L440GX+ Server Board Specification Update

Release Date: April 2001

Order Number: 245145-025

Figure 1-1. L440GX+ Server Board Layout

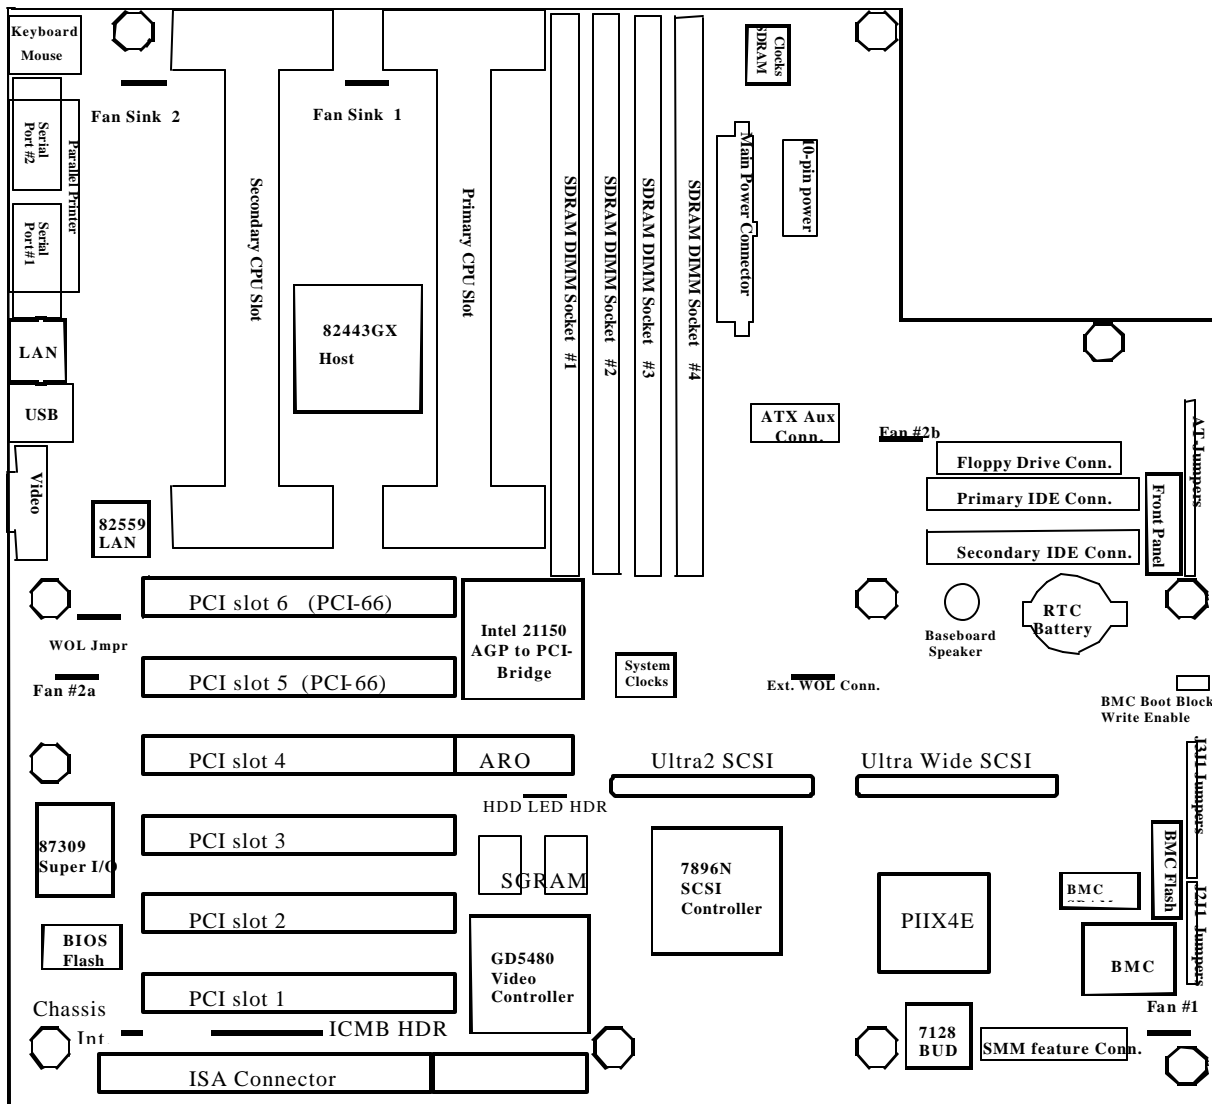
- Update to the L440GX+ component placement diagram, as shown in the rev 3.0 Technical Product Specification. The new diagram shows the addition of the 10-pin power connector found on L440GX+ server boards having a product code of BOXL440GX-H and later. The 10-pin power connector is used when the L440GX+ server board is integrated into an Intel SC5000 server chassis with redundant power supplies.
